Amendment C131 – Land Subject to Inundation Overlay and Floodway Overlay

Peer Review Report

Report Reference: R.M00450.002.01_C131_Review.docx
Date: 28 September 2023
Prepared for: Latrobe City Council

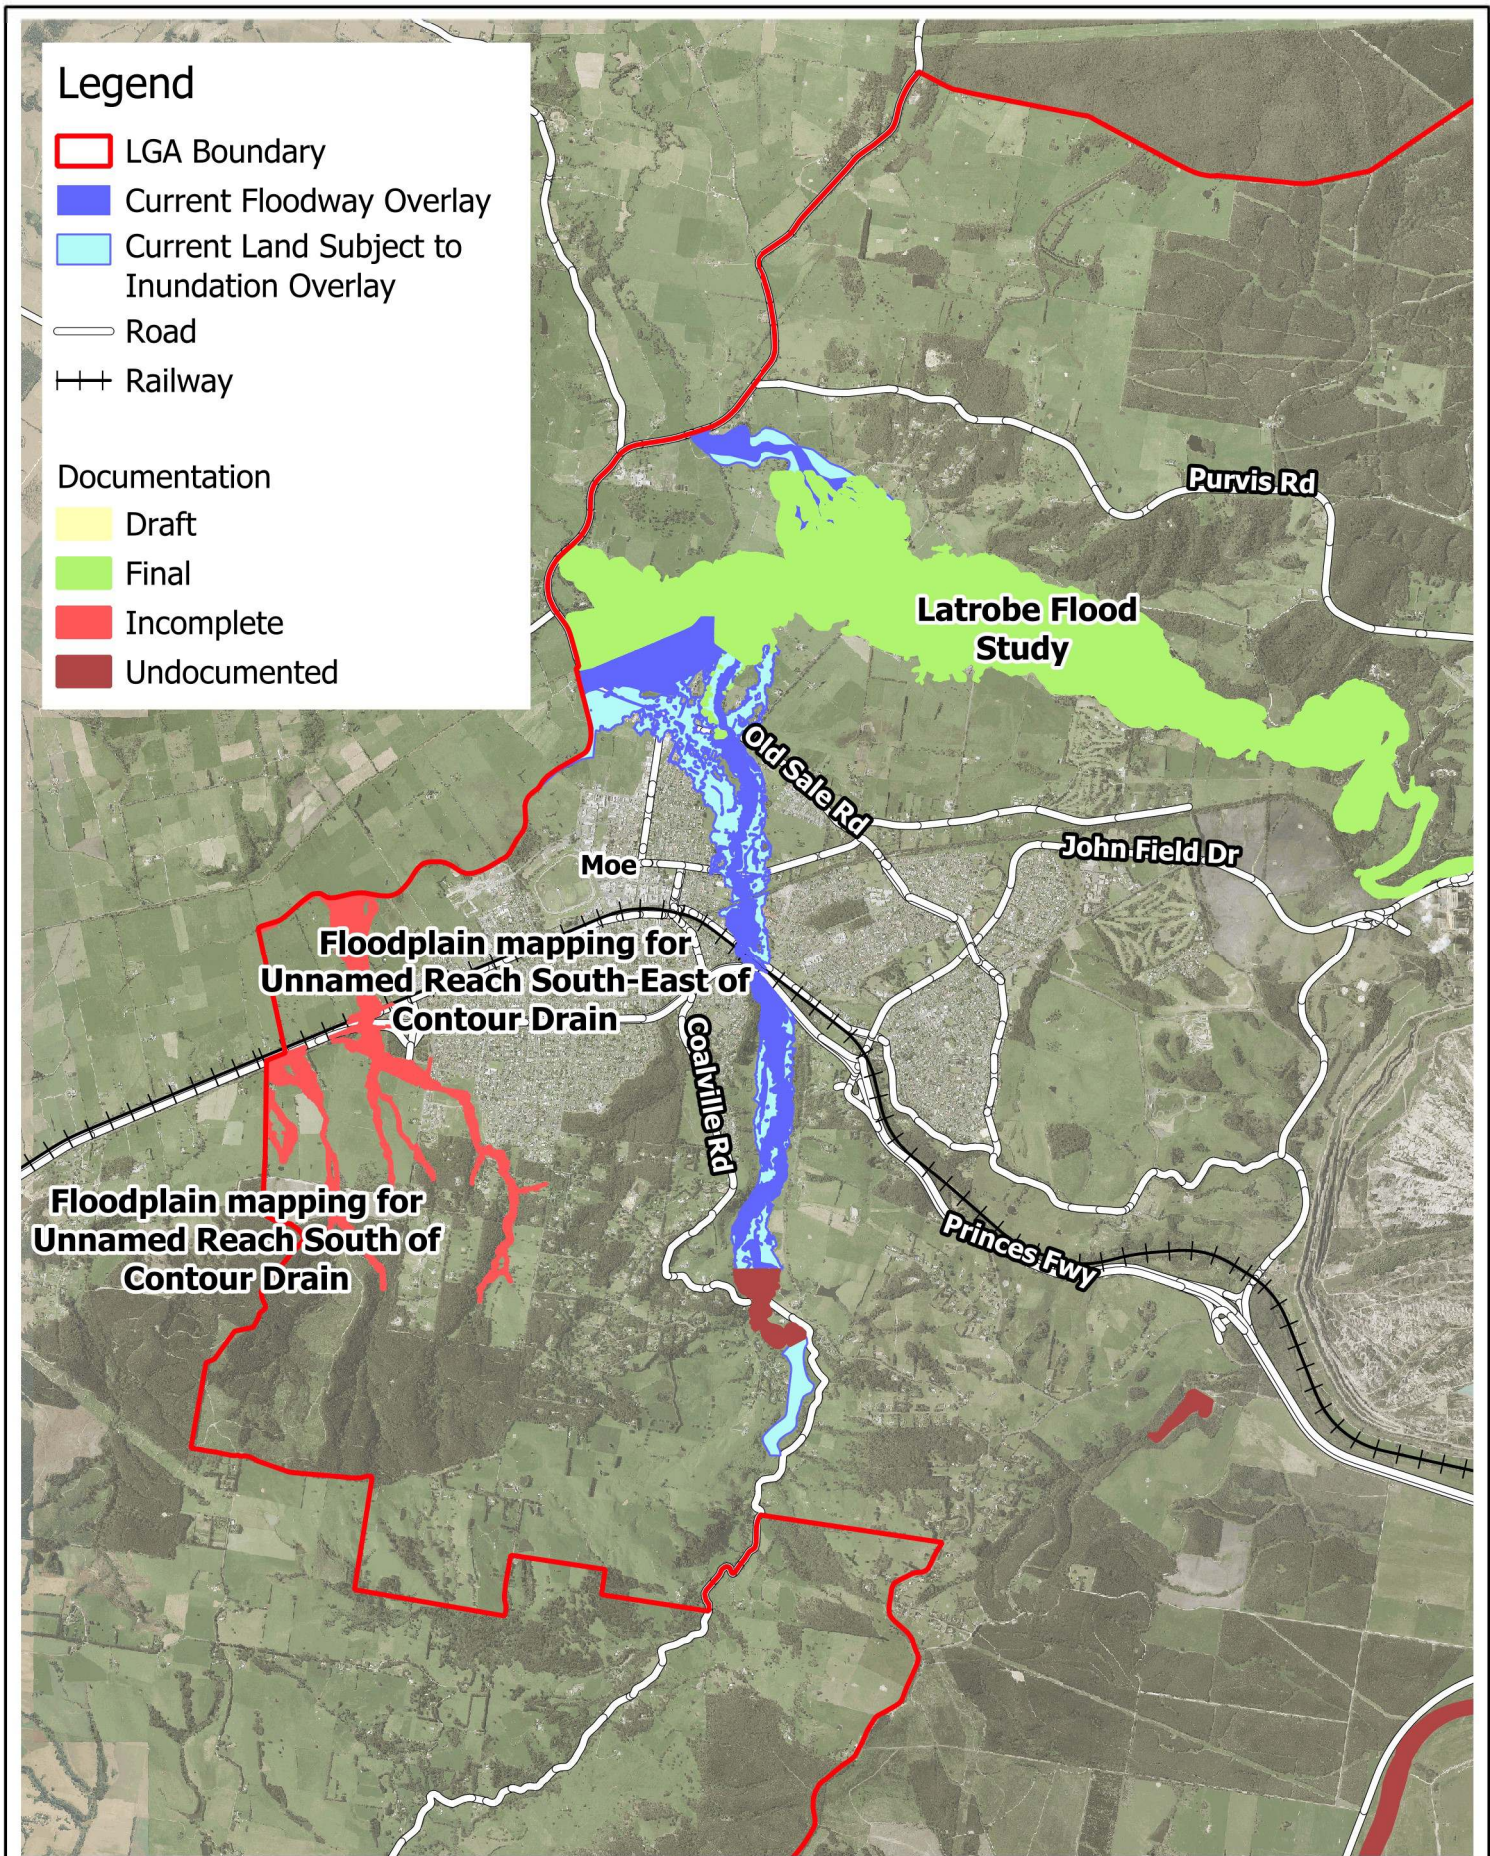
As listed in Table 4-2 and Table 4-3 and mapped in Figure 4-1, Figure 4-2 and Figure 4-3 there are several areas of Amendment C131 that are undocumented. These fall into two categories:

- Amendments based on flood modelling studies that the documentation is not available for as they were undertaken for 3rd parties and the documentation not made available to Council or the WGCMA
- Revisions made to the current overlays by WGCMA

While the technical veracity of the flood modelling studies might be suitable for a planning scheme amendment and the mapping presents the best available flood risk information for that area, without documentation this cannot be confirmed. Our experience in providing expert witness services for these types of amendments is that the panel requires assurance as to the technical veracity of the modelling work informing the amendment. As such it was agreed during the workshop to not proceed with amendments not supported by documentation.

For the revisions made to the current overlays by WGCMA it was agreed during the workshop that reasoning and method behind these revisions would be documented in either a standalone technical report or the Amendment C131 Explanatory Report.

Figure 4-4 Example of flooding in urban area (Glengarry)

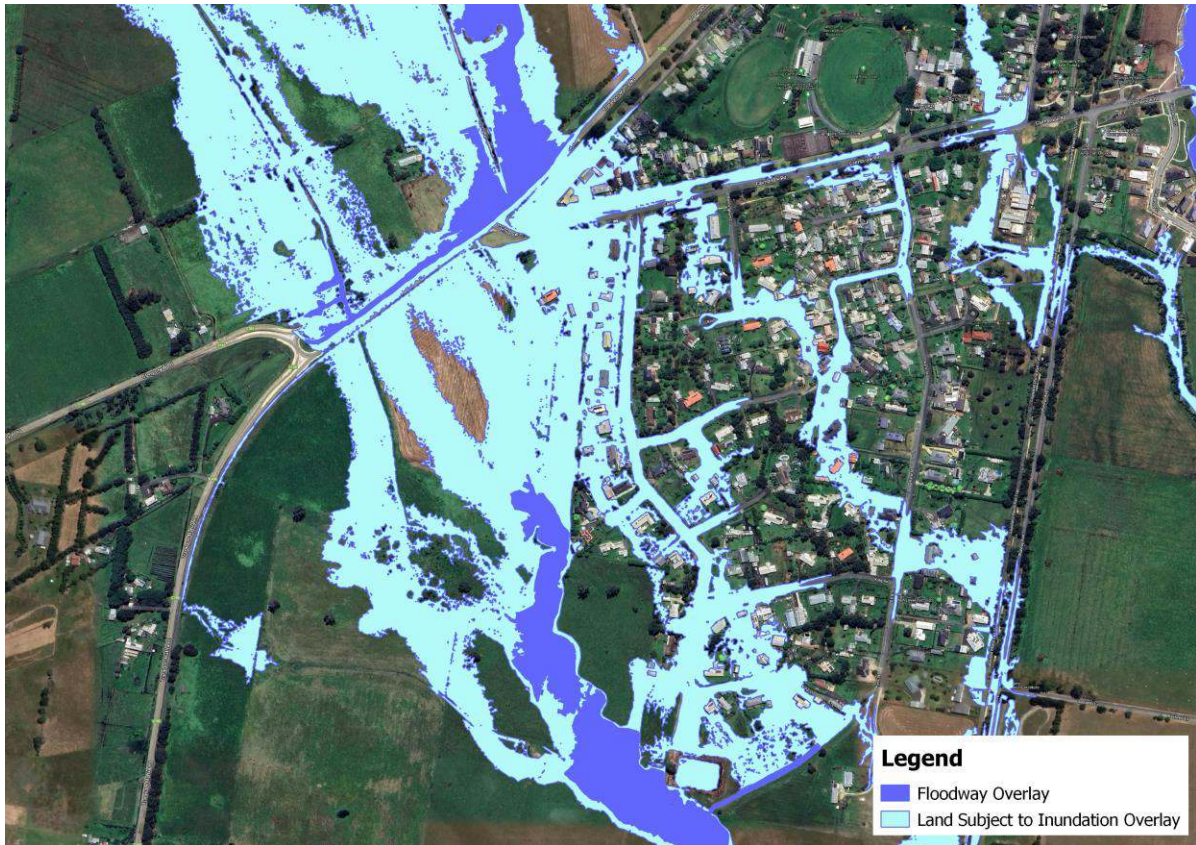
Other urban areas included in the overlays are from flood studies representing flooding originating from rivers, creeks, small watercourses and other overland flowpaths as opposed to the capacity of underground (pipe and pit) drainage systems being exceeded resulting in overland flow. As an example, while it is possible that undersized or blocked bridges, culverts and other drainage structures are contributing to the inundation in Glengarry (Figure 4-4), the flood model does not apply flow to the urban drainage network, rather all flow is applied to the watercourses and floodplain upstream of the township. Therefore while the mapped LSIO extends into the developed area the mechanism of this inundation is consistent with LSIO as opposed to SBO.
